## **Service Bulletin**

**No. :** MZ07-062

**Model:** SA-7S1

**Subject:** Improvement of the SA-CD TEXT display on the front panel.

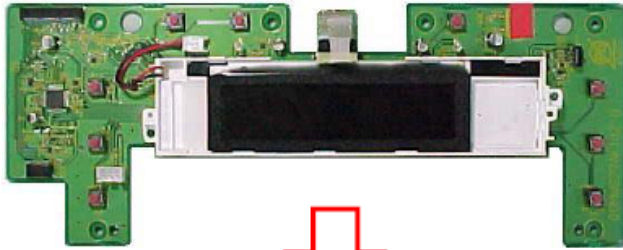
(1) Take the PY16 (FRONT 1 PWB) off the FRONT PANEL.

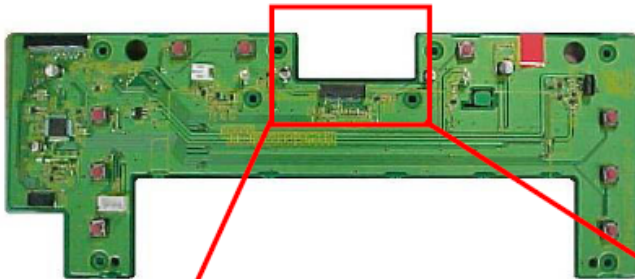
(2) Take the LCD unit off the PY16 (FRONT 1 PWB).

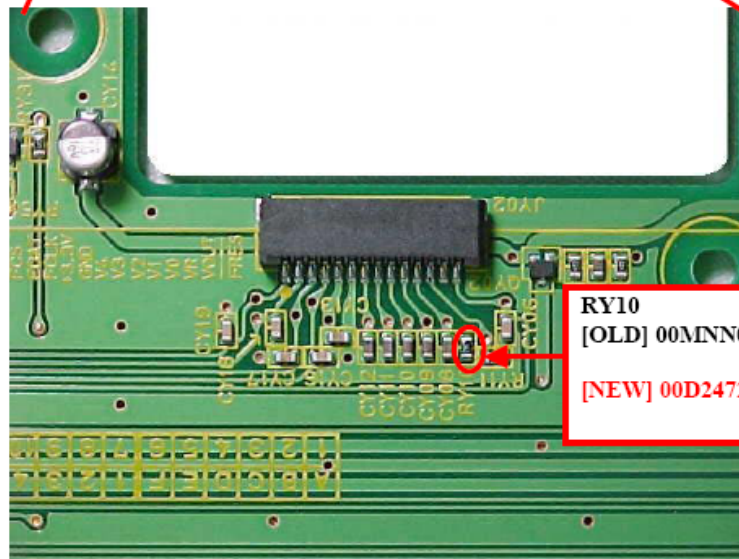
**Symptom:** When SA-CD TEXT is displayed on the front panel of the unit running from right to left, the letters look as if they flicker because the text display remains OFF for a longer time than it is ON.

(3) Replace the POS. NO. RY10 with a **CHIP RES. 62K OHM**.

**RY10**  
[OLD] 00MNN05563610 (56k OHM)  
[NEW] 00D2472011971 (62k OHM)
